AMENDMENT TO PRESTIGE BRICKWORKS PROPOSAL TO  
RE-DEVELOP THE MIDLAND ABATTOIR SITE, MIDLAND

PILSLEY INVESTMENTS PTY LTD

Report and Recommendations  
of the  
Environmental Protection Authority

Bulletin 308      November 1987

SCALE 1:2000  
 SHEET 2 OF 2  
 DRAWING NUMBER  
 P 8581-MK ?  
 Fig 2.

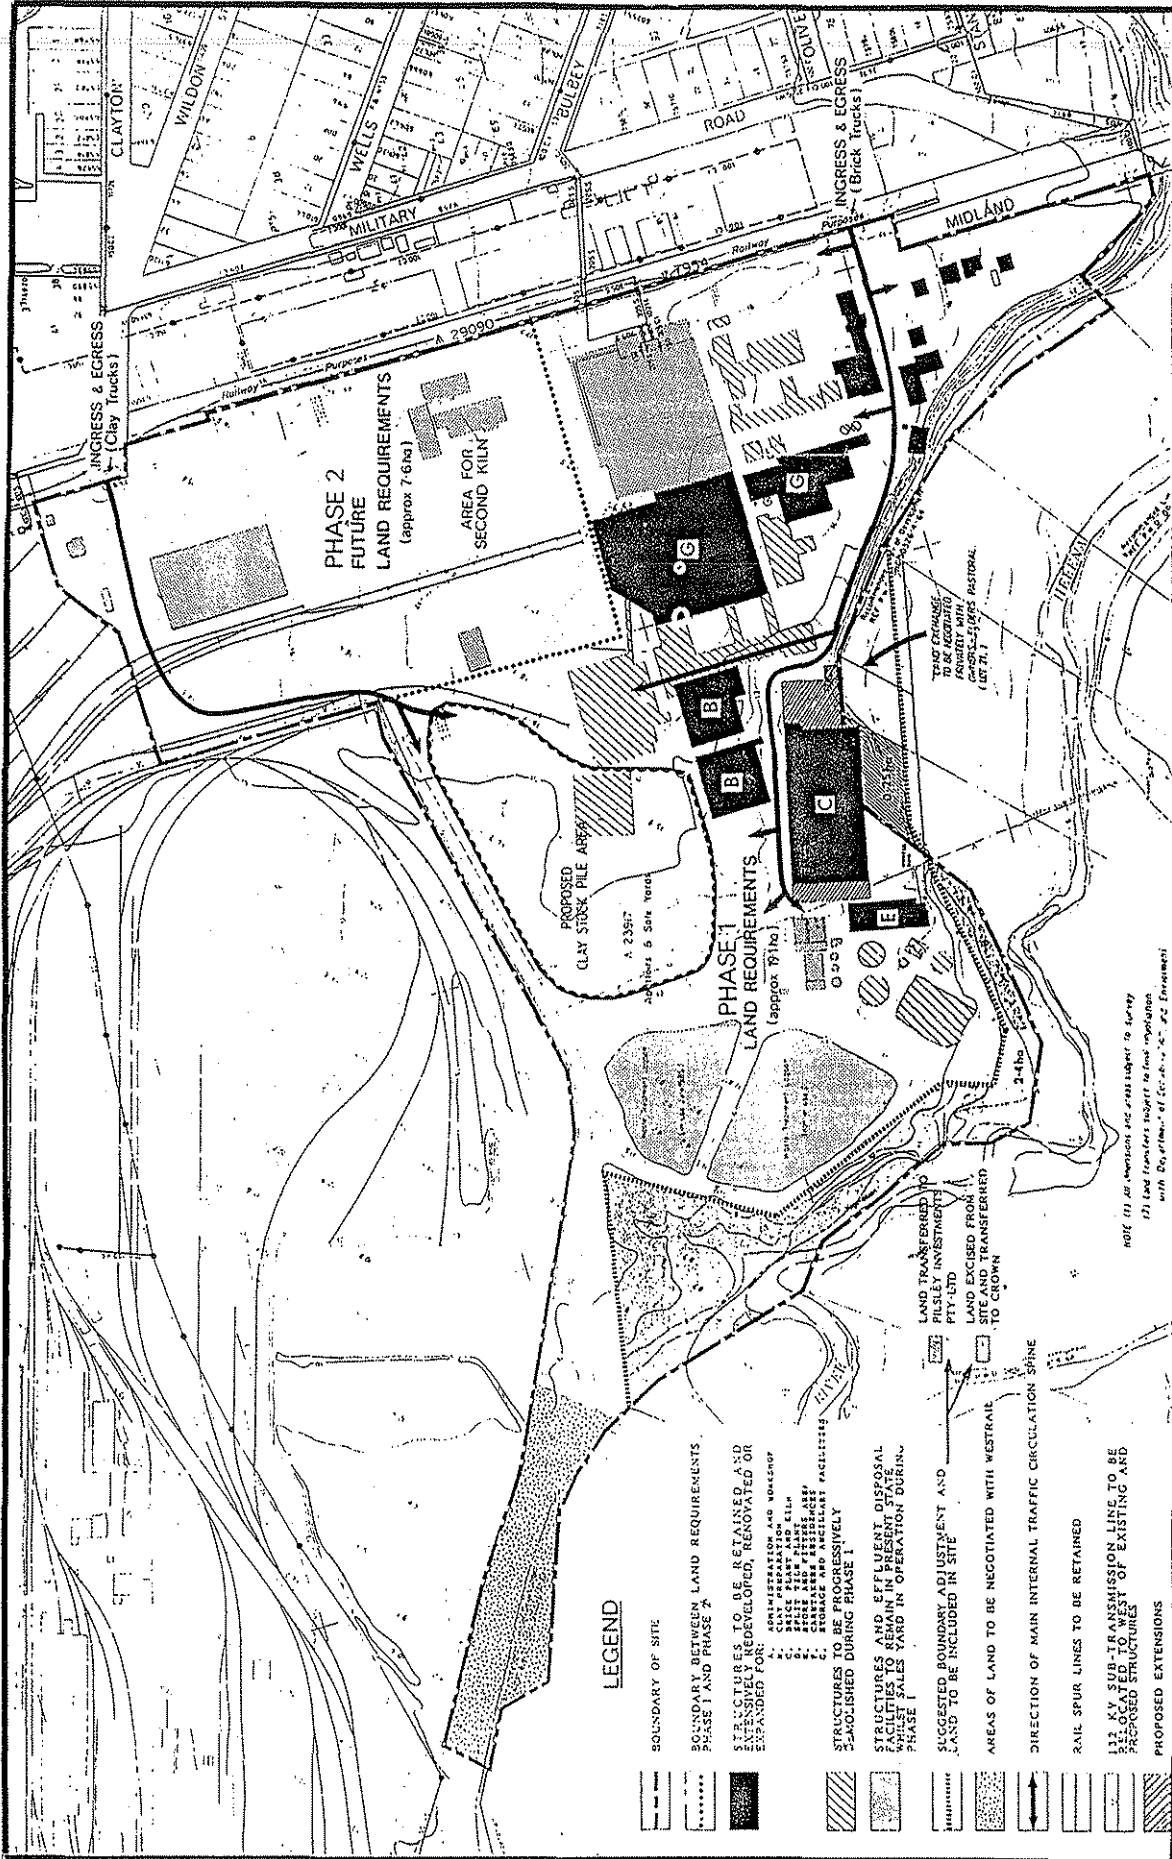
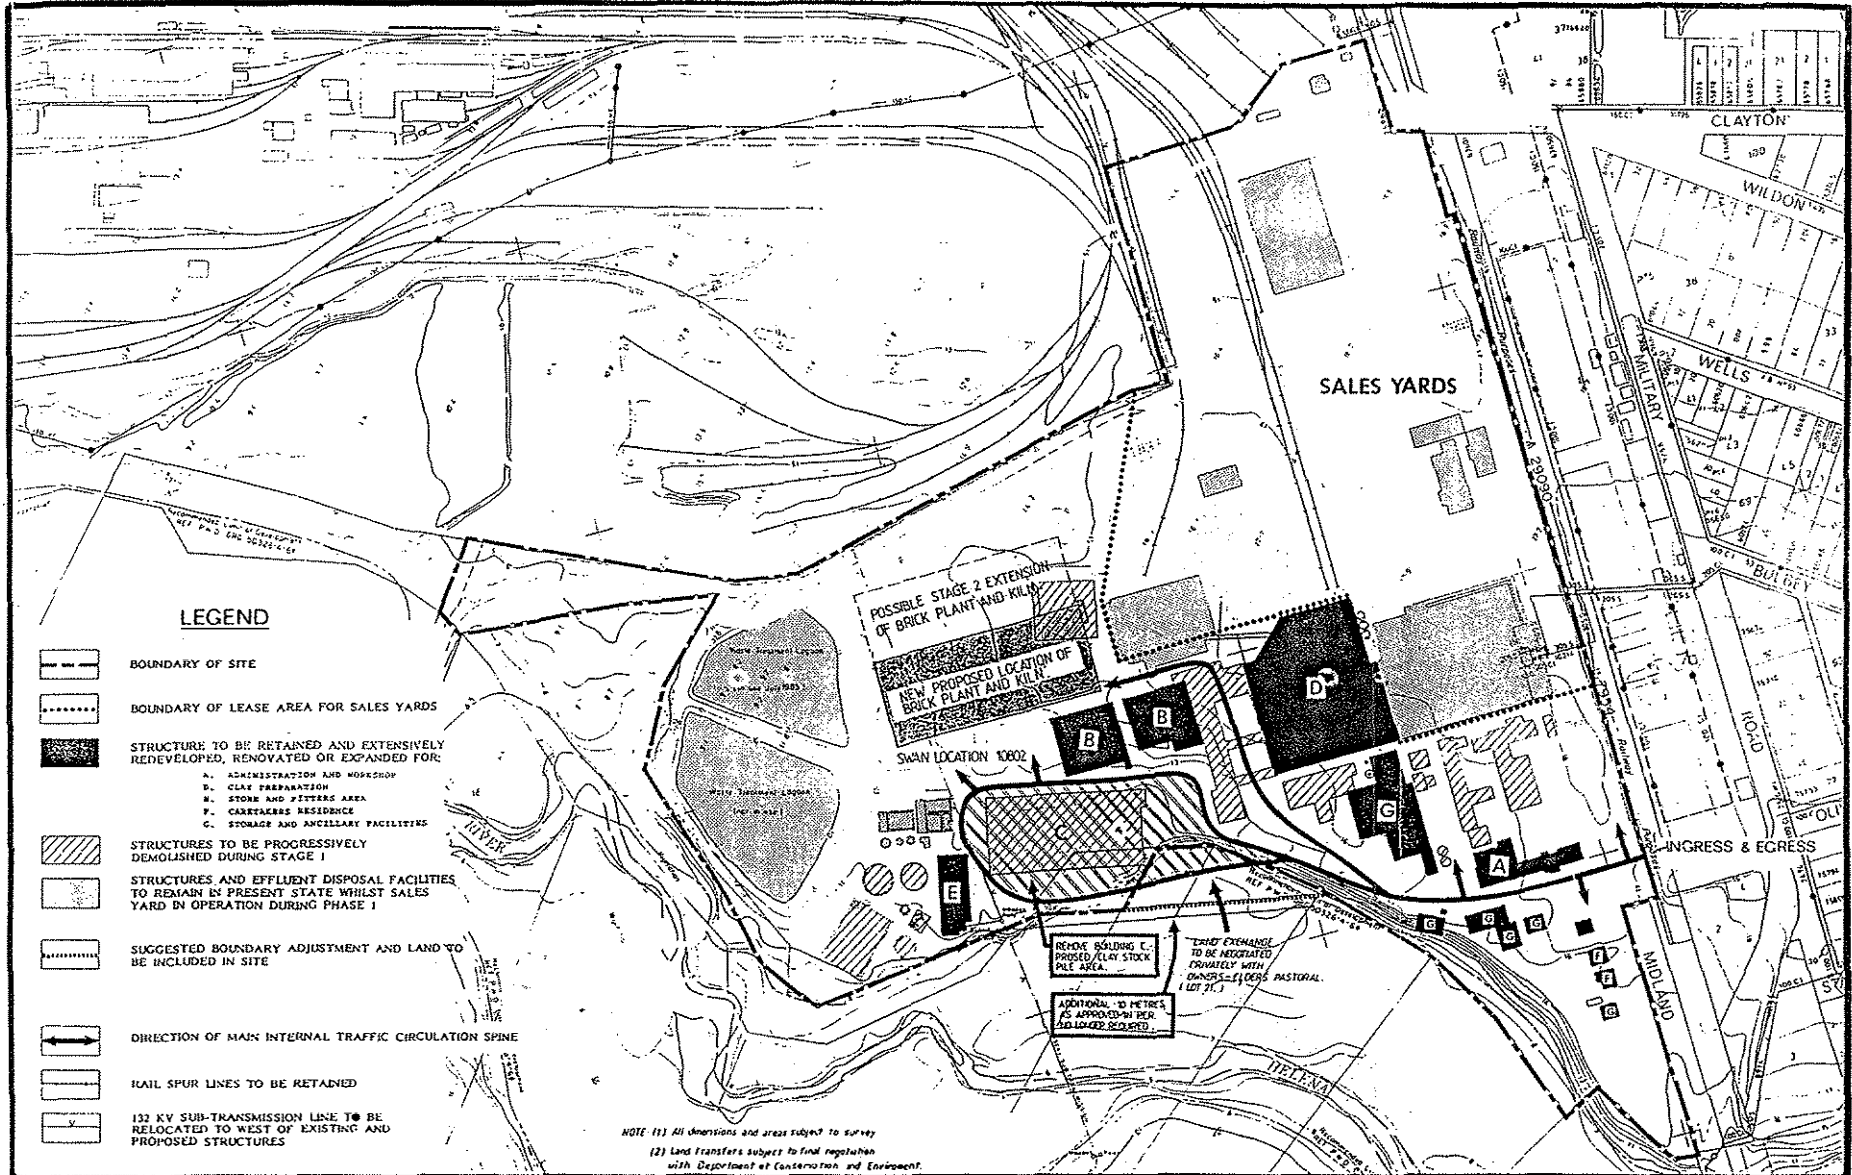
The NOI included a Plan showing the layout of the initial proposal. This Plan has been reproduced in the Report as Figure 1.

The proponents have reported that the foundation capacity of the proposed site of the brick plant and kiln, shown as 'C' in Figure 1, is unsuitable.

It is now proposed to locate the brick plant and kiln within the area that had previously been proposed for the clay stock pile area. This involves a shift of the emission stack by about 130 metres to the north.

The clay stockpile would be sited on the southern boundary in the area that had previously been identified for the brickworks and kiln.

The amended layout is shown in Figure 2. With these modifications there is no longer a need for a 10 metre by 210 metre long strip that intruded into the Helena River Flood plain. The Company has offered to make this ten metre wide strip available to the Crown at no cost to assist with the provision of the proposed Helena River linear park.

Isopleths for Ground Level  
Concentrations of Flourides  
Stack Height 35 m.

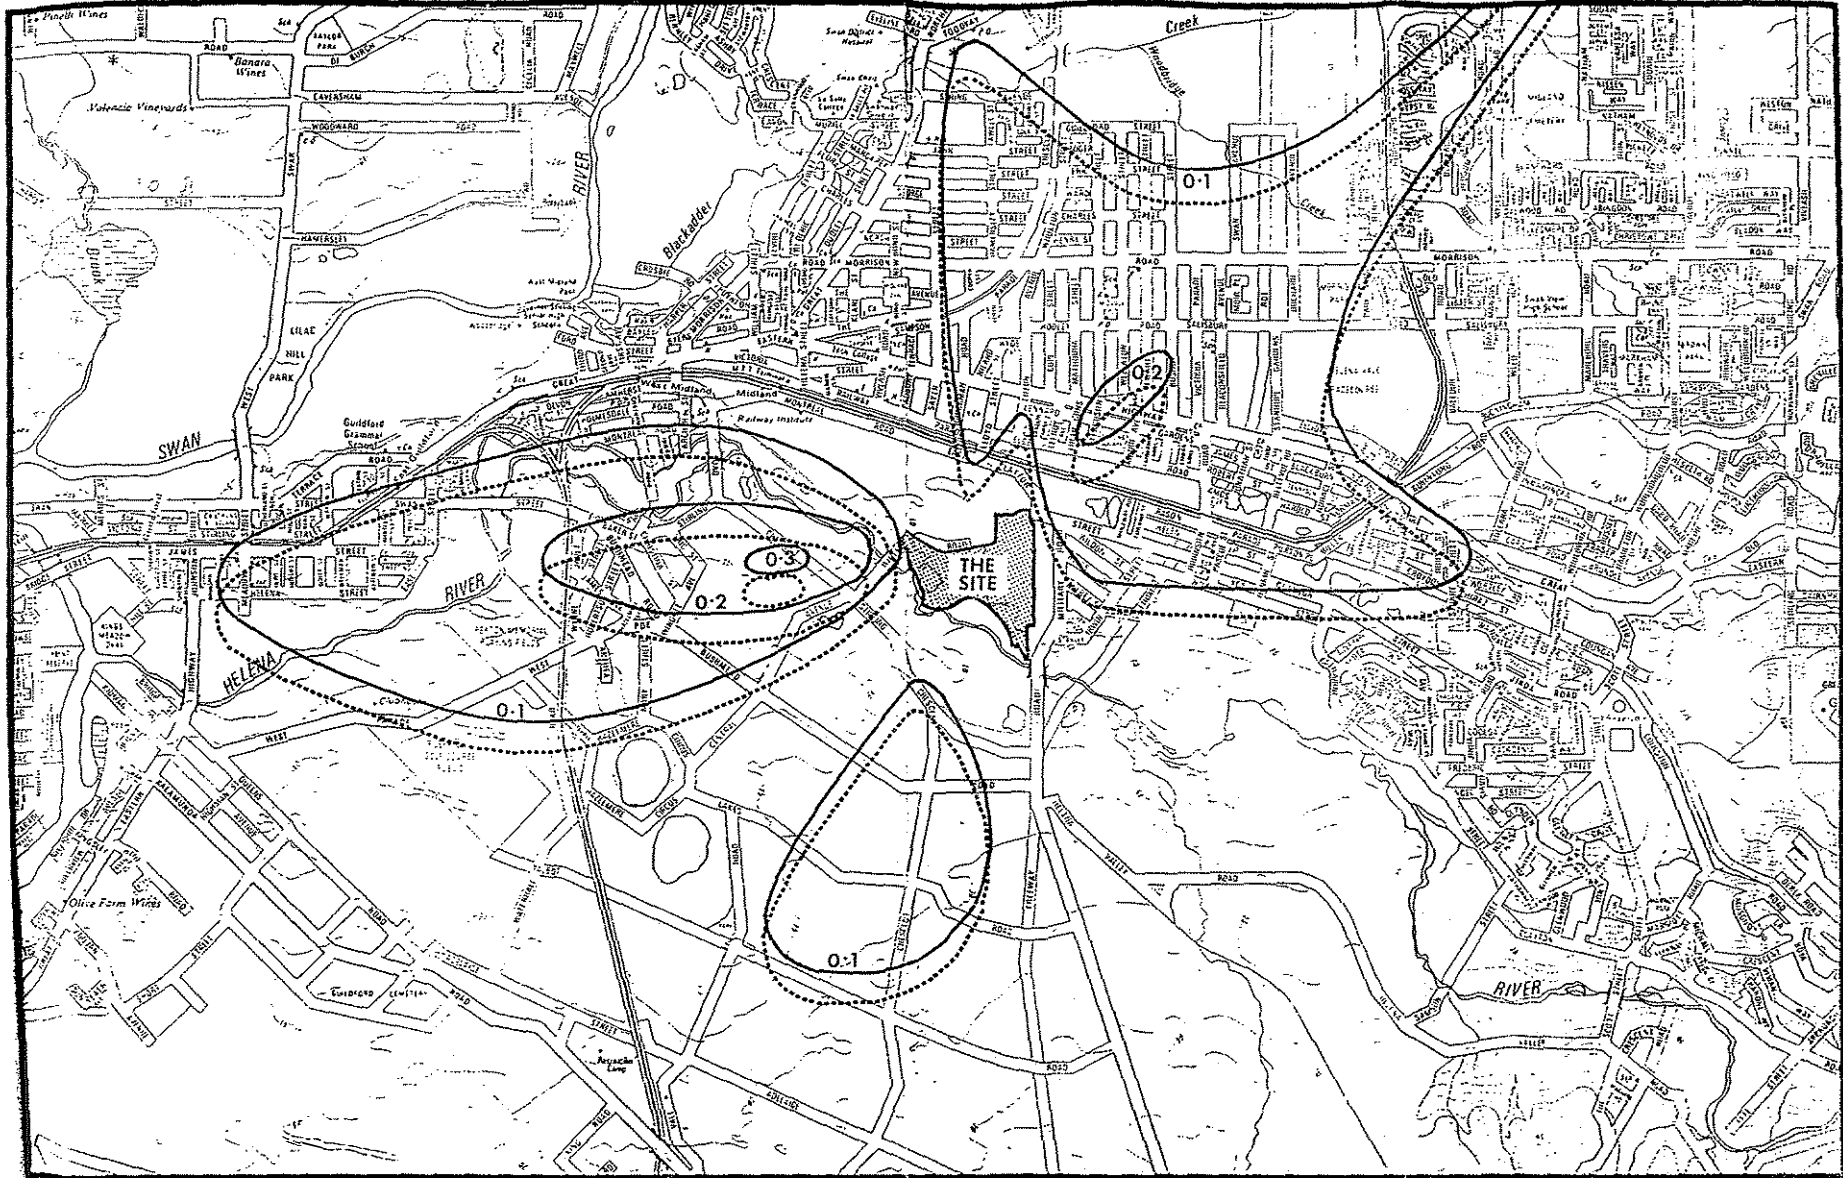
The proposal described in the NOI has adopted a 35 metre stack and the predicted ground level concentrations of fluoride for the new location of the kiln compared to these for the kiln located on the southern boundary of the site are shown in Figure 3.

The Authority agrees that these predictions of ground level concentrations of fluoride are a very good representation of the expected fluoride levels.

The relocation of the kiln with the emission stack to be sited approximately 130 metres further north of the site described in the PER, will mean on average that the ground level concentrations will be translated by a similar distance. The area of greatest impact west of the brickworks, with a predicted ground level concentrations of 0.3 micrograms a cubic metre, will in essence still be the same general area in Hazelmere as that mentioned above. The 0.2 microgram a cubic metre impact zone to the north east of the new kiln location will now encompass the southern portions of Wellaton and Ewart Streets, as well as Ferguson Street, but will now exclude Moore Avenue.

Notwithstanding the conservative approach adopted by the dispersion modelling, it means that there are only two relatively small areas where the ground level concentrations are expected to reach or exceed 0.2 micrograms a cubic metre.

For most of the surrounding area the average three month concentrations are at the 0.1 microgram a cubic metre level or less.

The Authority agrees with the proponent's conclusion that the relocation of the 35 metre high emission stack to a position approximately 130 metres north of the original location will have negligible effects on humans, grazing animals and no effect on commercial horticulture or viticulture in the region.

There could be minor plant damage to sensitive plants in the area impacted by the 0.3 microgram a cubic metre ground level concentration zone. This particular area is presently largely cleared and undeveloped.
